UNITED STATES PATENT AND TRADEMARK OFFICE

Office Action Summary

10/821,737

DETAILED ACTION

Fig 1

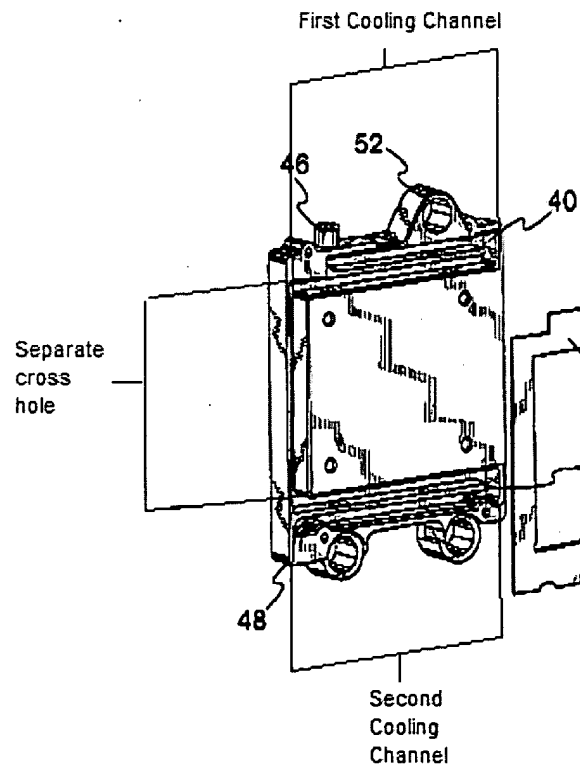
With respect to claim 9, Clamp et al. further teaches that the cooling plate has separate cooling channels (As illustrated in Fig 2, the first cooling channel is located near 40 and a second, separate cooling channel is located near 44).

With respect to claim 10, Clamp et al. further illustrates that the separate cooling channels are connected by at least one separate cross hole (Running along the left side of the bottom as illustrated in Fig 2 and present office action Fig 1 below).
